RE: Levy County Nuclear Power Plant Discharge into Existing Florida Barge Canal

While reviewing the submitted NRC application as submitted by Progress Energy for the Levy County Nuclear Power Plant, I noticed the discharge point for the new nuclear plant facility would occur at the existing Crystal River Nuclear Power Plant discharge outlet. I can understand the engineering reasoning behind this decision. As shown on the proposed site plan, the planned discharge pipe would run parallel along the North bank of the barge canal and eventually cross the canal near the canal's entrance at the Gulf of Mexico. The pipe would continue to the existing nuclear power plant facility.

This brings me to the purpose of this letter. This letter is a engineering proposal that is being submitted that should be consider for discharging the nuclear power plant cooling water at a point where the proposed discharge pipe was going to cross the canal. Additionally, next to discharge location, a earth or concrete dam with a lock system would need to be provided on the west side of this discharge outlet. This would create a close system for recycling the cooling water for the new

CONCEPTUAL COOLING BASIN PLAN
NO SCALE

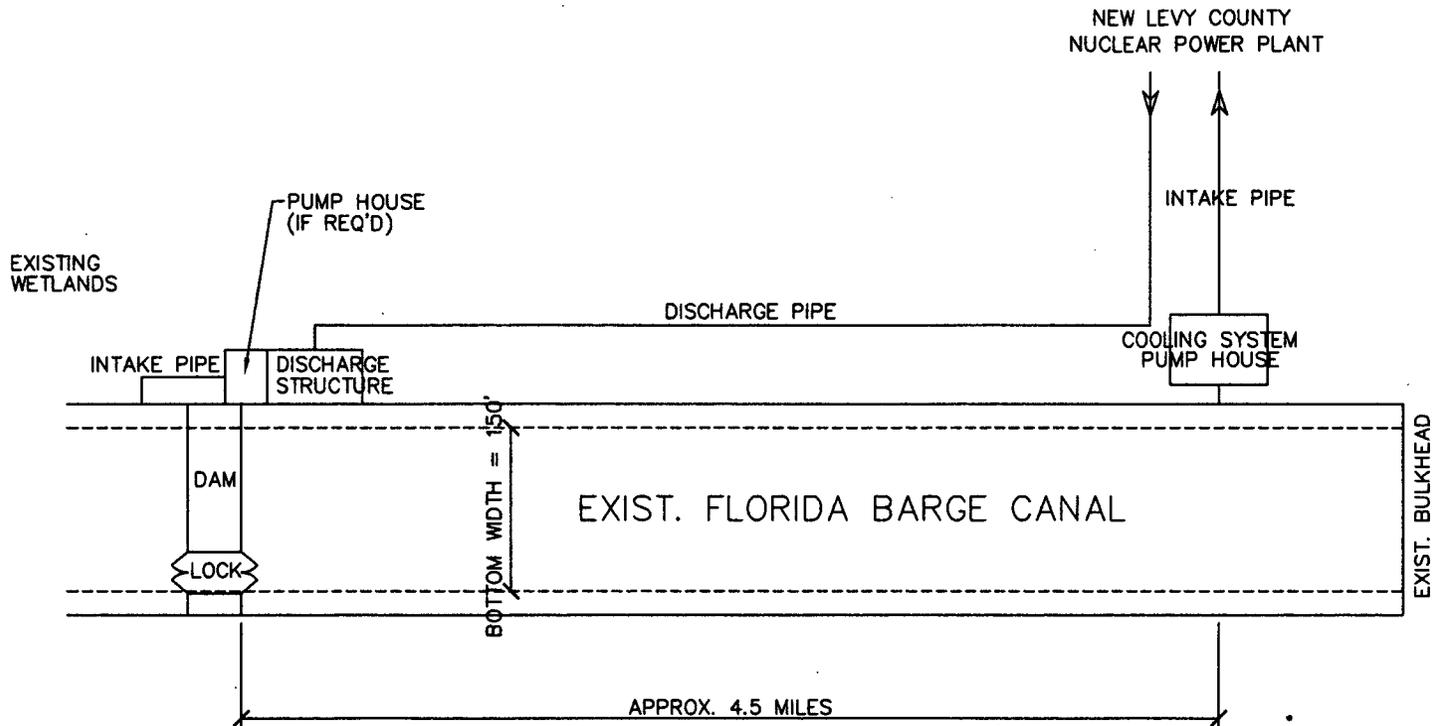
I have run some preliminary calculations, to determine the estimated cycle time of the water contained in the new formed cooling basin. See Attachment #1 to this letter for a proposed layout of the infrastructure needed as outlined in this letter. The numbers are as follows to determine the estimated recycle time:

With a bottom width of the existing canal at 150 feet and an estimated depth of 12 feet, the average cross section of the existing barge canal is determined to be approximately 2,000 square feet. The separation point between the intake structure and discharge outlet and dam structure would be approximately 4.5 miles long. This creates a volume of stored water of approximately 47.5 billion cubic feet contained within this basin. It is my understanding that the daily flow for use in cooling this nuclear facility is to be 1.85 million gallons per day (247,300 cubic feet). If this is the case, the cycle time for recycling water within this basin would be a total of 192 days. Hopefully, a time period long enough to sufficiently cool the 95 degree discharge water?

Another benefit the basin could also provided if it is used as a manatee sanctuary area during the winter months since a lock at the dam enable passage to the cooling basin where the water is warmer during winter months. The lock could be open occasionally and be used as a staging area to allow the mammals to enter the basin. The lock could also be used for any barge traffic which needed to enter the basin for the nuclear power plant or other purposes. It also would allow water to be added to the basin if the level became low. I also have shown a pump station as an option rather than using a lock for this purpose.

Another benefit would be the reduction of 2.5 miles of discharge piping along side the Gulf of Mexico. With less piping, the pumping system for the discharge system would need less horsepower therefore providing additional construction cost savings. Also, I believe wetlands presently exist between the existing barge canal and the Crystal River Nuclear Power Plant. By
